**REPORT OF THE MONITORING TEAM OF THE INSTITUTE FOR
ENERGY AND ENVIRONMENTAL RESEARCH**

**INDEPENDENT AUDIT OF LOS ALAMOS NATIONAL LABORATORY
FOR COMPLIANCE WITH THE CLEAN AIR ACT, 40 CFR 61,
SUBPART H IN 2001**

CONCERNED CITIZENS FOR NUCLEAR SAFETY

December 18, 2002

Figure 1 November 2001 gamma dose rate at the NEWNET East Gate (new) station
Note: the 41 $\mu\text{R/hr}$ value on 11/28 was considered to be erroneous

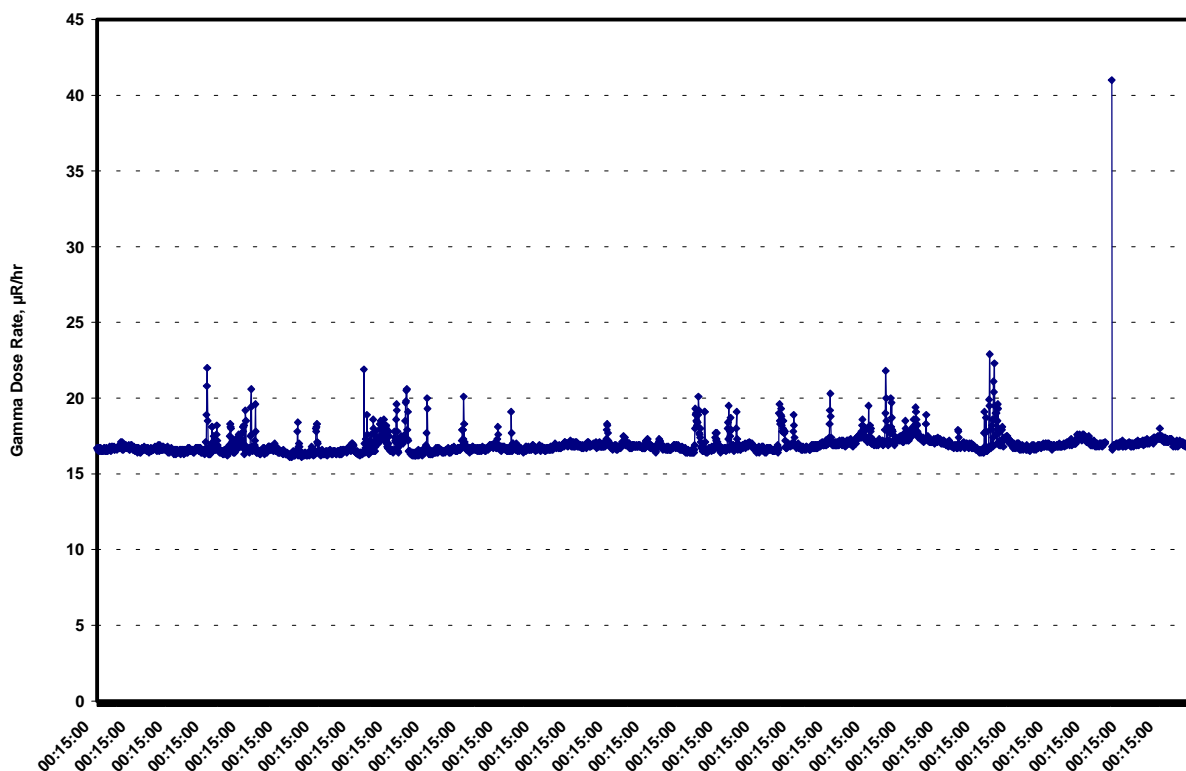
I present a somewhat different approach for the month of November 2001. Upon inspection of the gamma dose rate over time (Figure 1), a gradual shift is evident which may likely be due to instrument calibration.

Figure 4 December 2001 gamma dose rate at the NEWNET East Gate (new) station as a function of wind direction in degrees

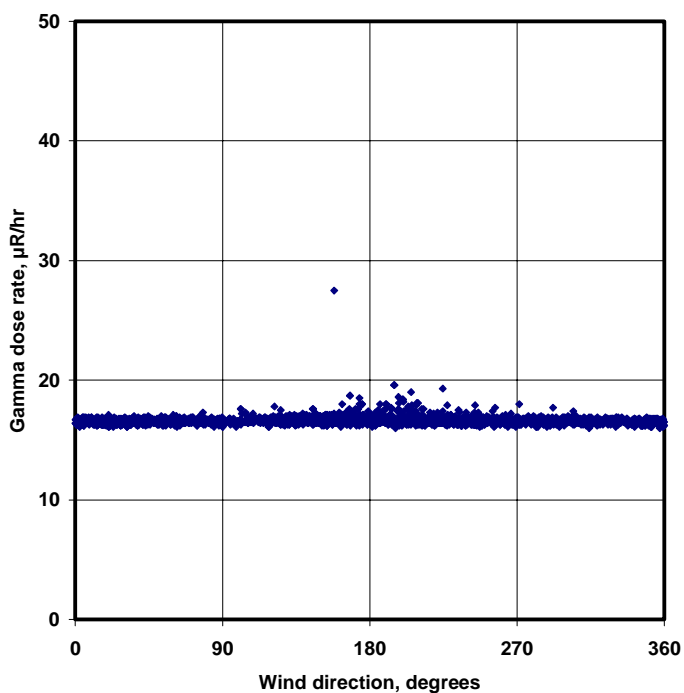
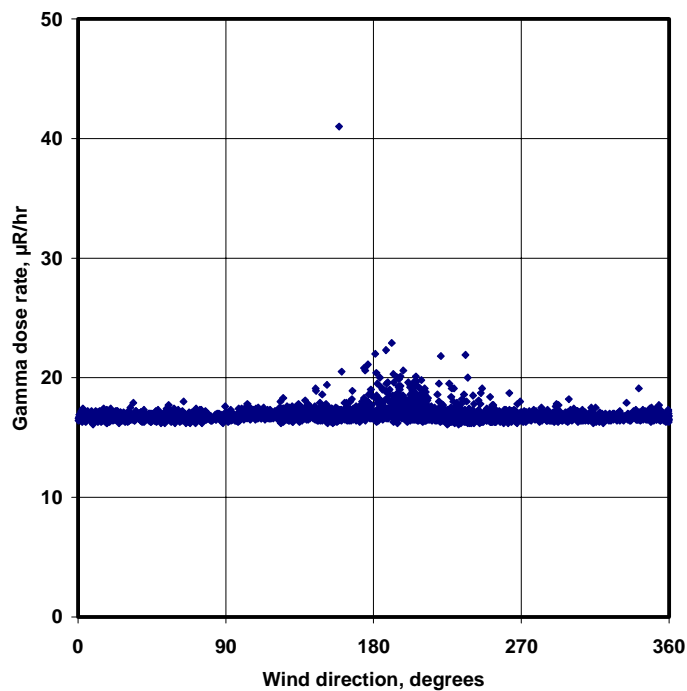
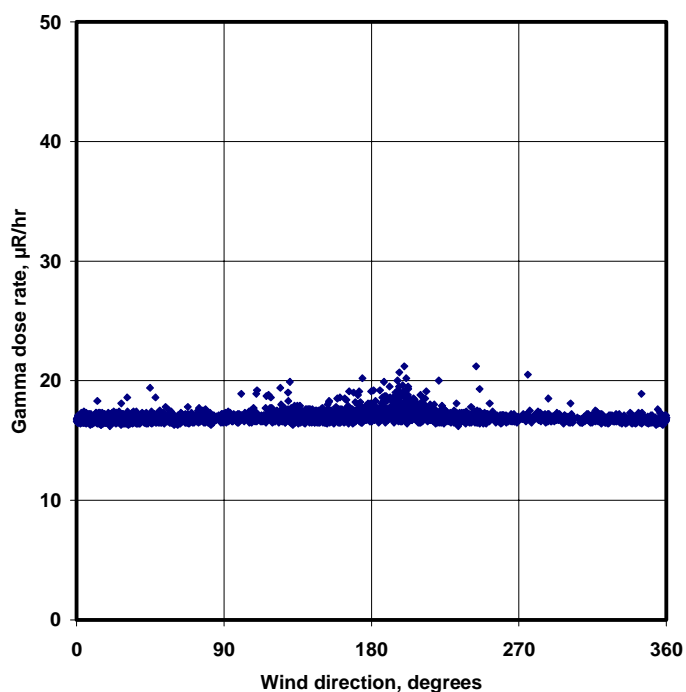
In addition, I would like to direct attention to the gamma dose rates as a function of the wind direction in the month December 2001 (Figure 4) compared to the data for October 2001 (Figure 2) and November 2001 (Figure 3). The increases in gamma dose rates at wind directions <90 and >270 degrees in the month of December 2001 are difficult to explain and may indicate electronic

noise at this station. That comes as a surprise because the station East Gate (new) was equipped with new data loggers that are supposed to have rectified the noise issue.

I suggest that ITAT continues the review of NEWNET data quality and the methodology to use NEWNET data to validate the results of CAP88 calculations.

Figure 1 Wind speed as a function of wind direction at East Gate NEWNET station, August 2002

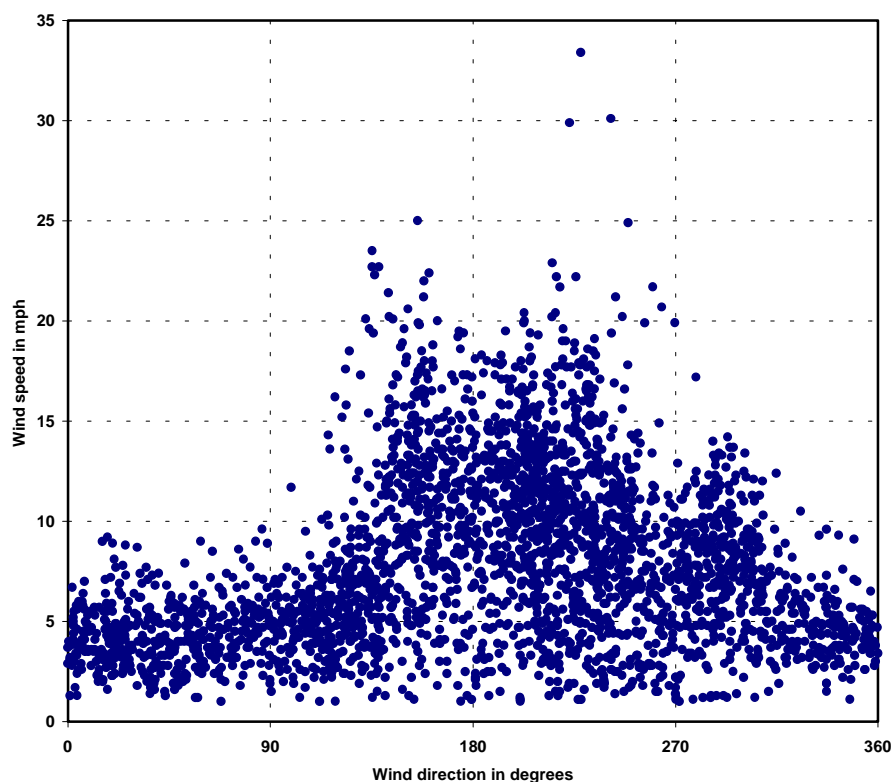
The underlying calculation assumes a steady-state release and is modelled with a simplified flat-terrain model. Both assumptions are not valid in this case. The use of a complex terrain model may lead to a different conclusion for a "TA-21 East" source. In addition, the releases from a diffuse source are most likely to occur during high wind speeds (>10 mph) when material can be readily suspended into air. High wind speed situations are more likely during wind blowing from the South/Southeast (see Figure 1).

With regard to diffuse sources at TA-21-East, the wind speed/direction pattern suggests that the greatest impact to residents from such a source is likely at the North Mesa residences.
